**MINUTES  
BOARD OF BUILDING STANDARDS/  
ARCHITECTURAL BOARD OF REVIEW/SIGN REVIEW  
REVIEW MEETING  
CITY OF LAKEWOOD  
12650 DETROIT AVENUE  
AUDITORIUM  
AUGUST 11, 2022  
5:30 P.M.**

**ARCHITECTURAL BOARD OF REVIEW**

**Docket No. 08-52-22 (13429 Cliff)**  
Porch Addition

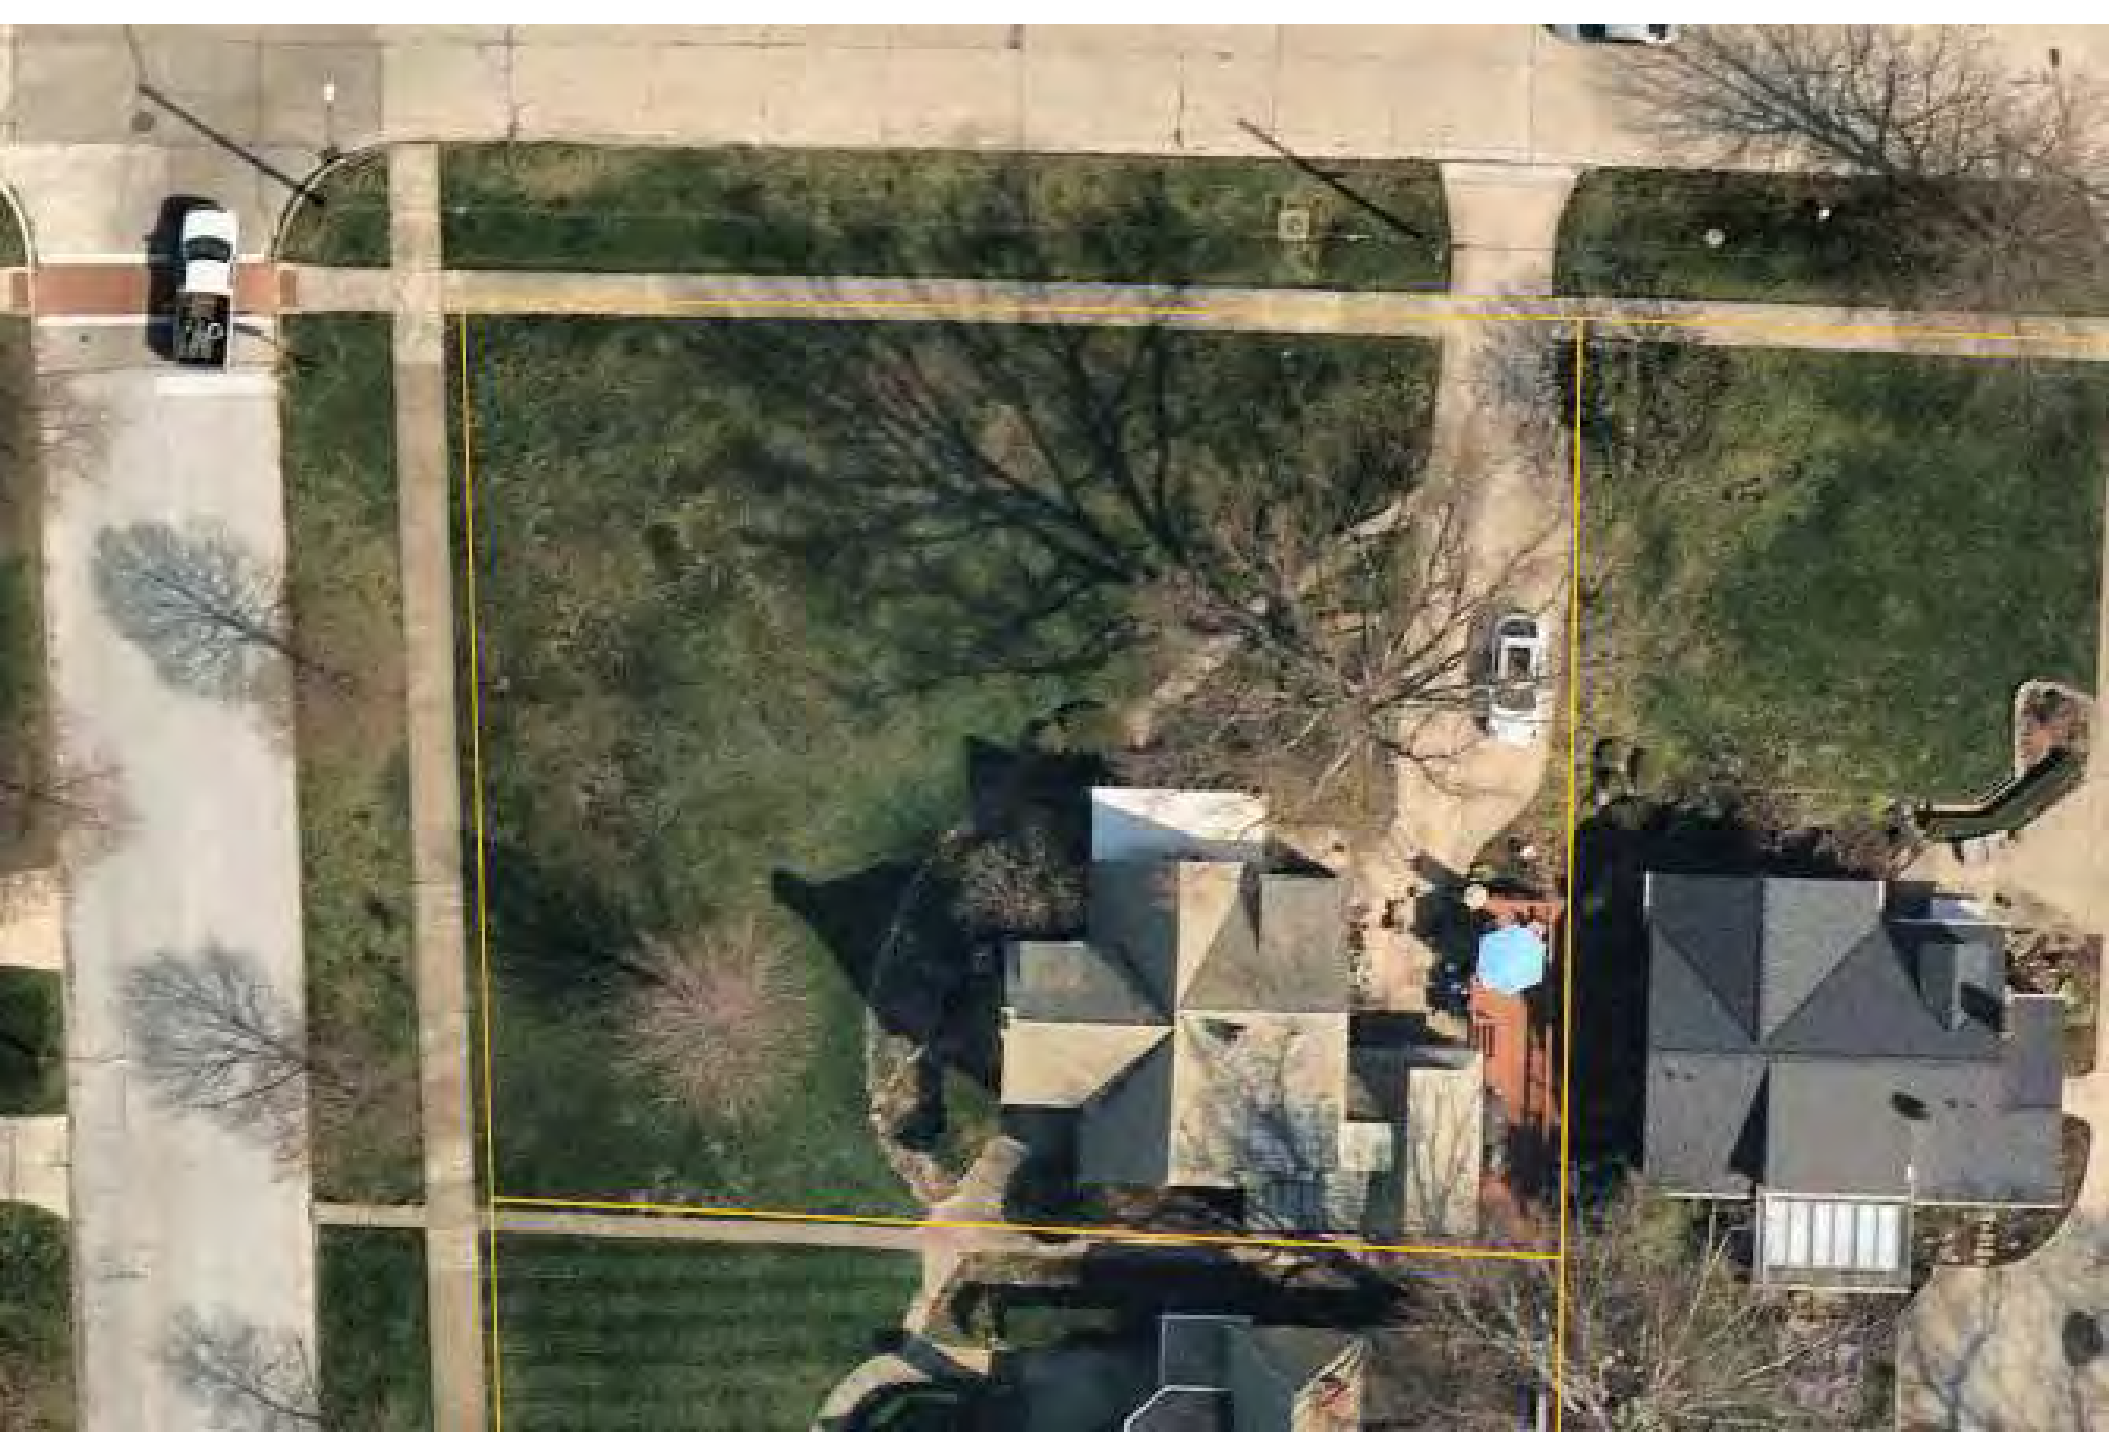
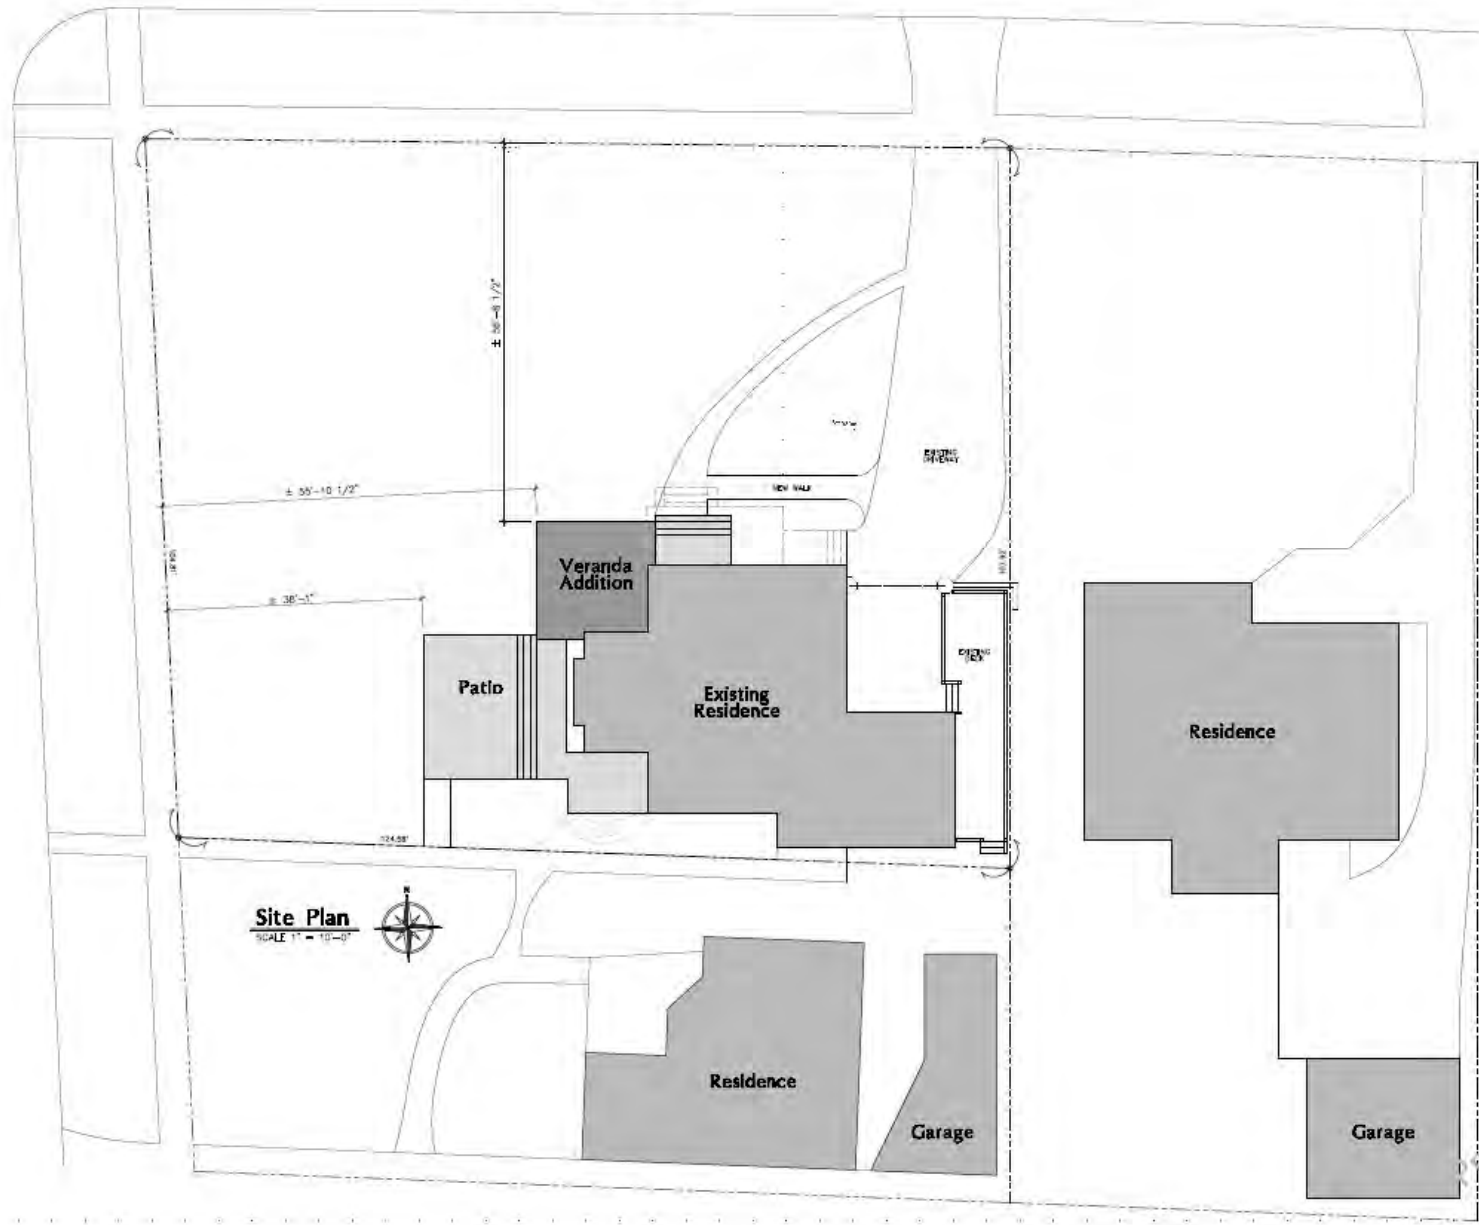
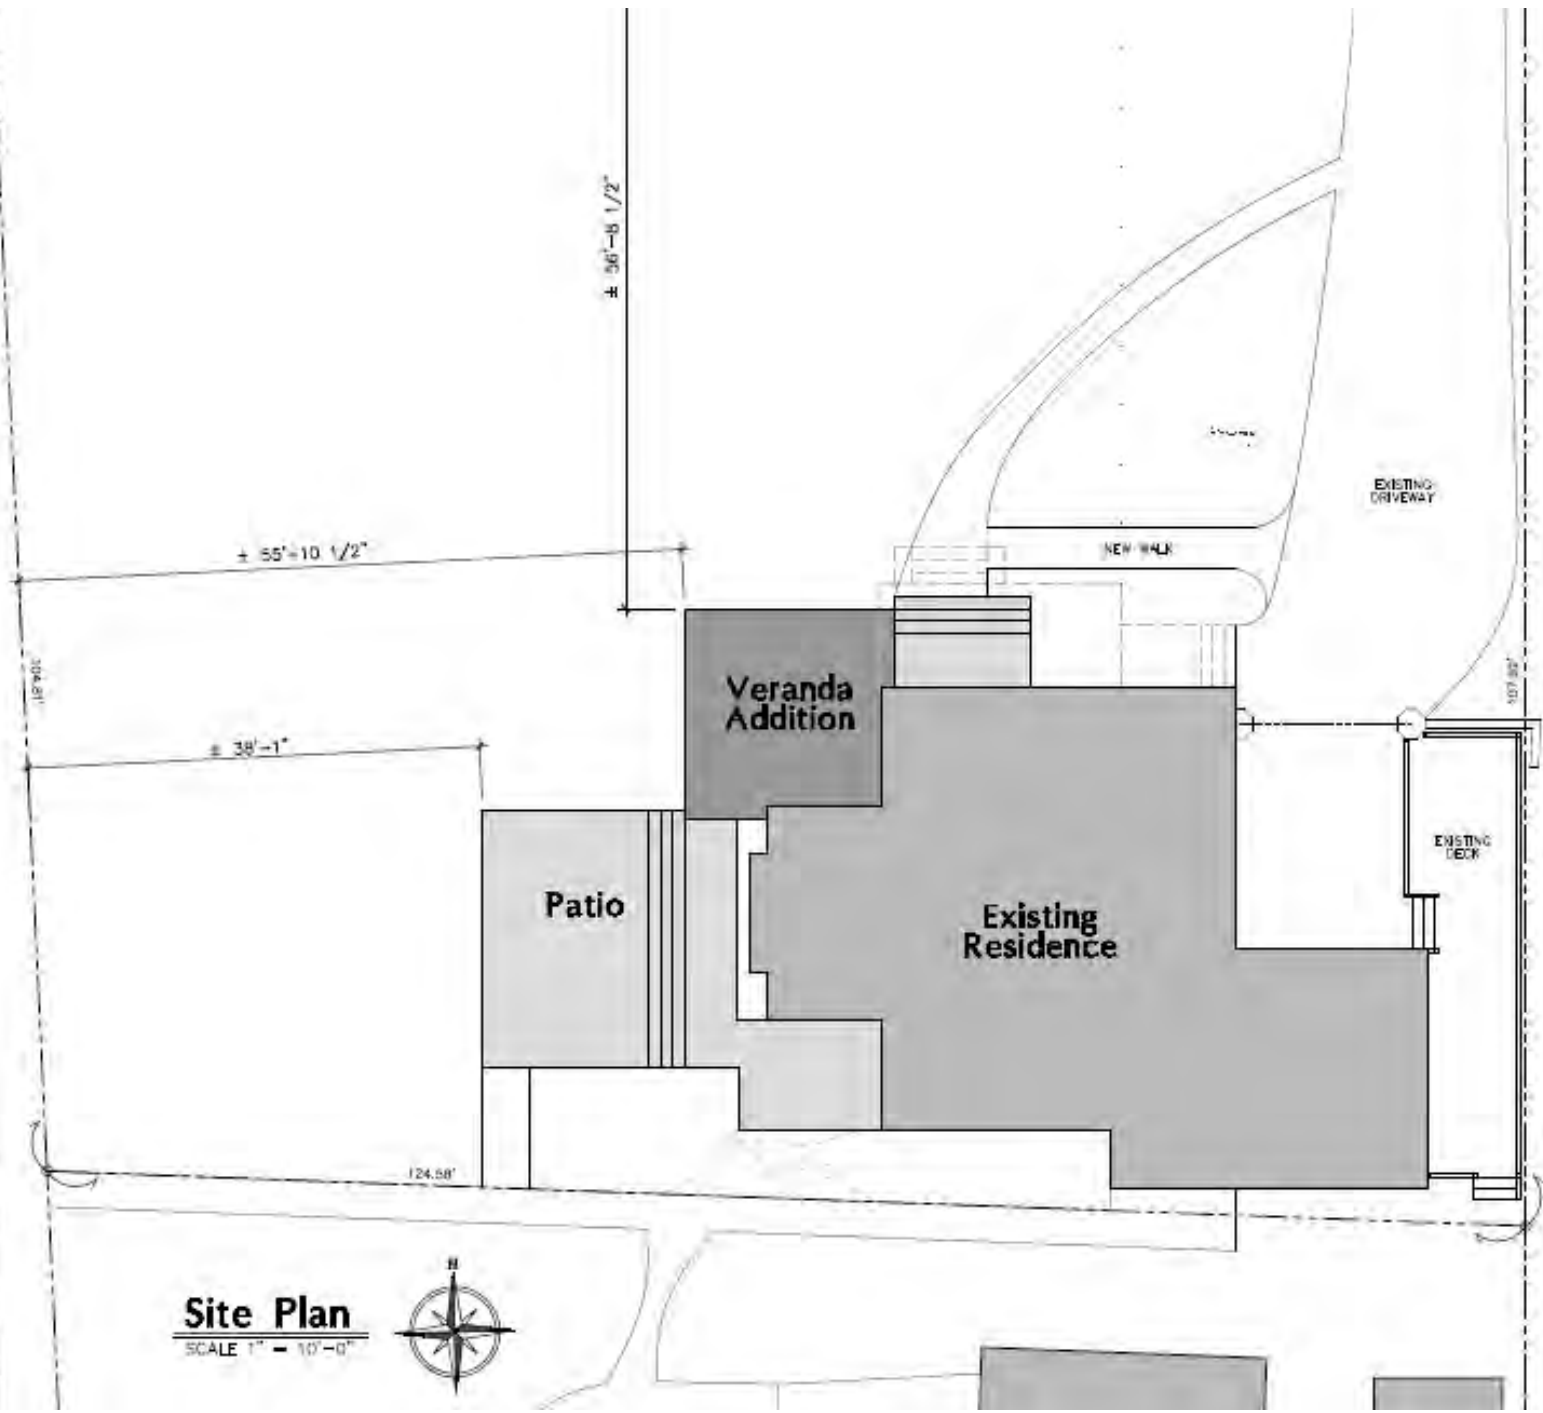
- Pending BZA consideration for uncovered patio deck height.
- Applicant proposes to paint/treat existing uncovered masonry on home (standards provided)

**Docket No. 08-55-22 (13701 Lake)**

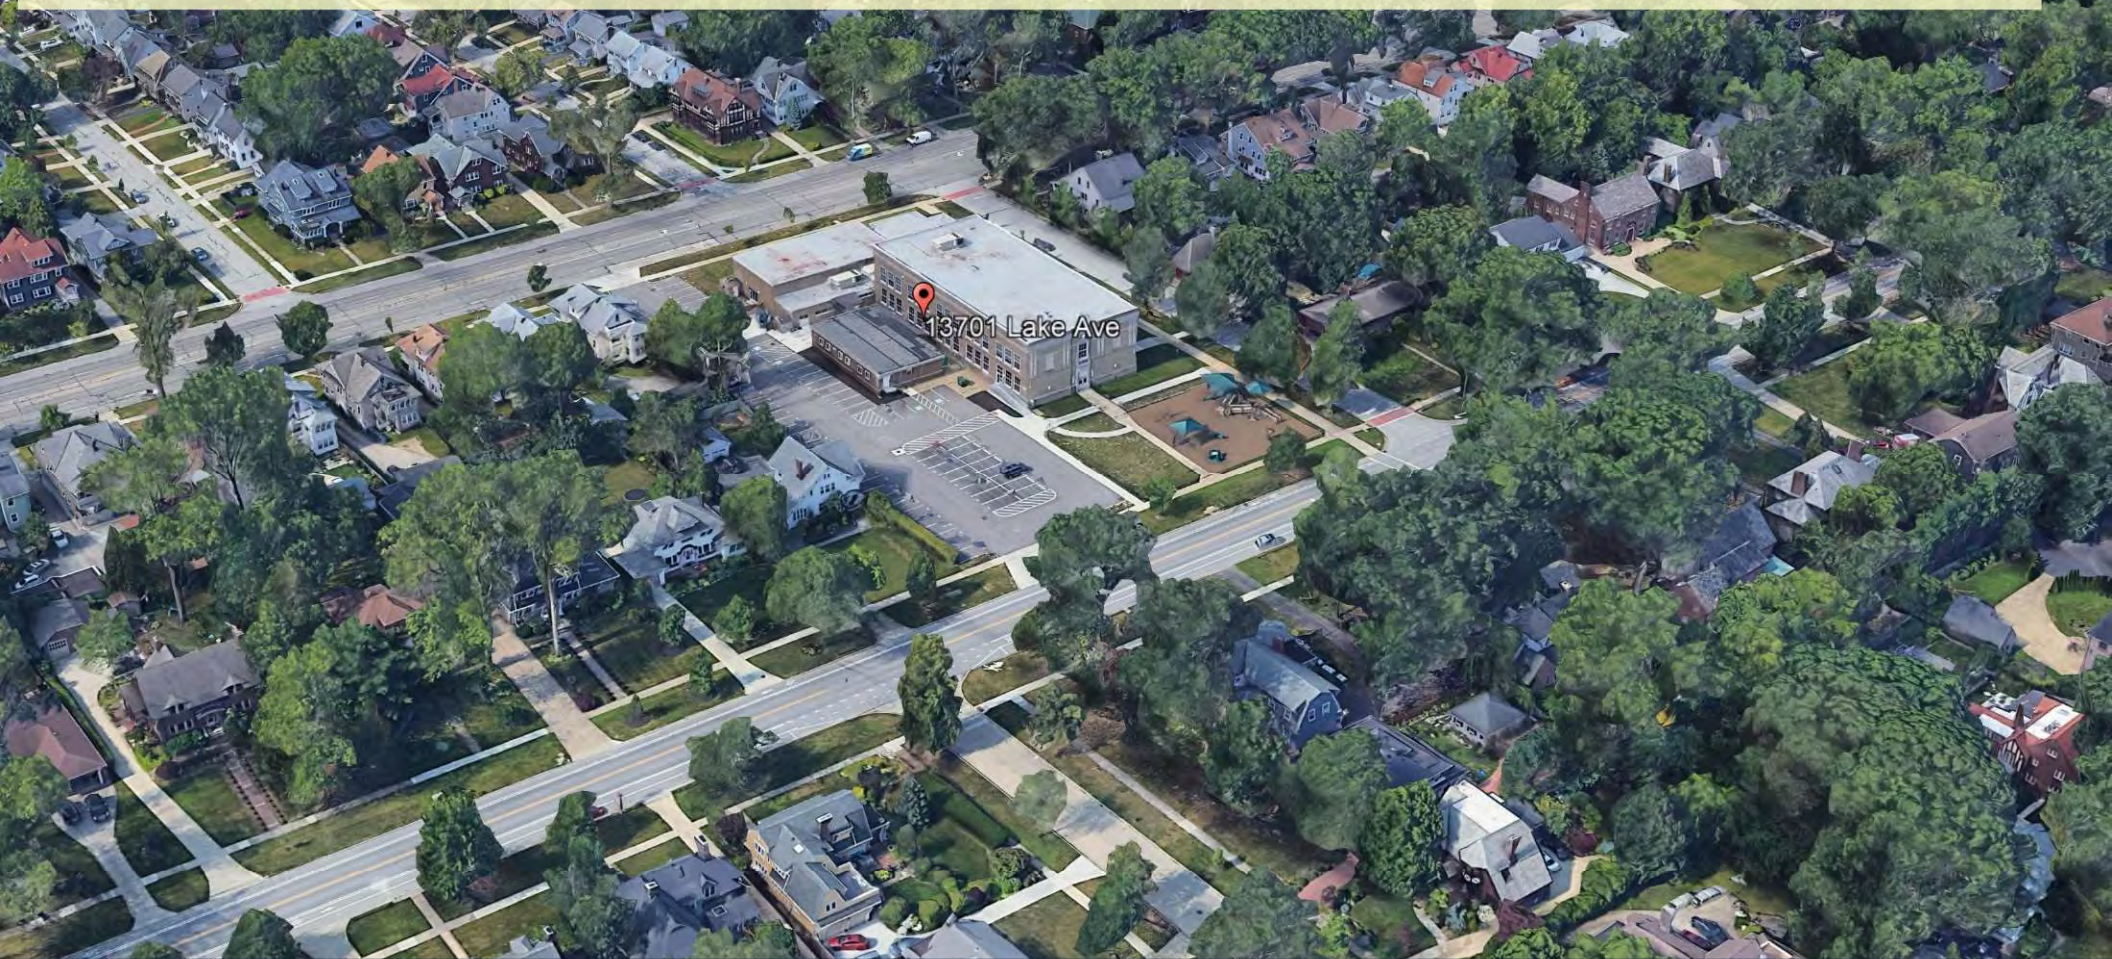
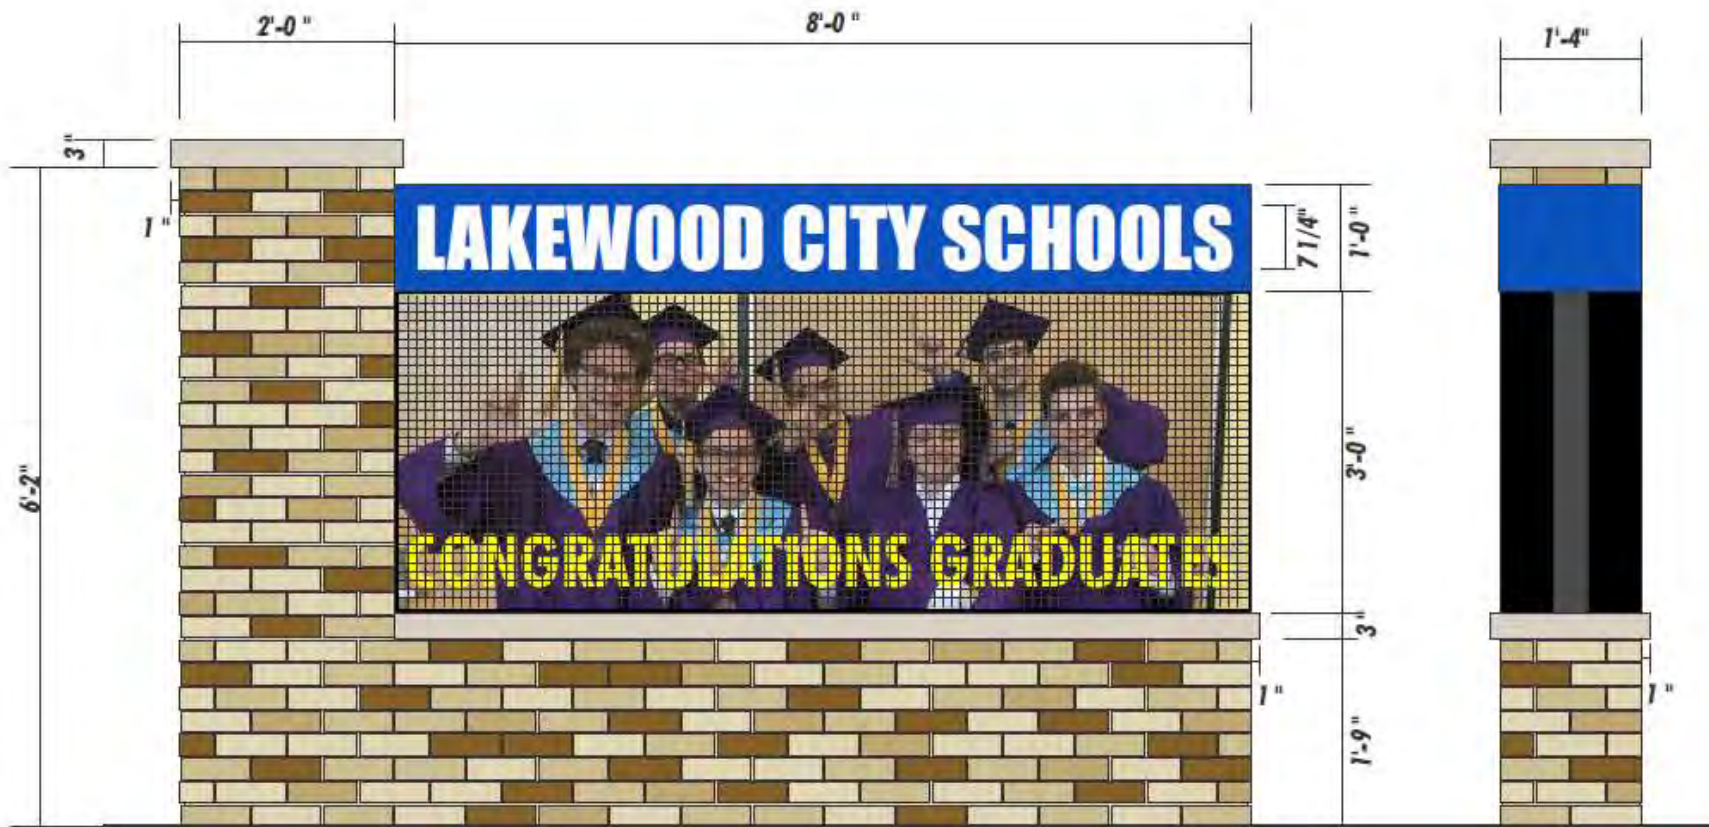
Laura Higgins-Wyoma, Brilliant Electric Sign Company, applicant and Chris Donahoe, Lakewood City Schools were present to explain the request. Discussion began about brick (would match the building as closely as possible); the vertical column/pier would face the street (members suggested it to face the building); the font (color might be changed to "Lakewood" purple), the monument sign would match the one at the High School. Public comment was closed as no one addressed the item. Staff do not receive any communication.

- Maximum allowable sign area of 100 ft<sup>2</sup>
- Earlier approval (Nov 2020) for wall lettering (~22 ft<sup>2</sup>).
- Proposal to add one ground/electronic reader board sign (~32 ft<sup>2</sup>)

- The electronic reader board ("ERB") message sign will:
  - Not blink, flash, scroll or strobe.
  - Be limited to a single color on a dark background with copy changing at an appropriate interval as to provide sufficient turnover of information, but not present a hazard to pedestrians or motorists.
- The ERB message sign is used for a government function and display information to the public.
- The monument sign cabinet containing the ERB will be between 10 and 12 inches in width with length as proposed. The width and length of the supporting brick base will extend uniformly on all sides of the cabinet as shown in Option B.
- All directional and building signage is approved as presented.
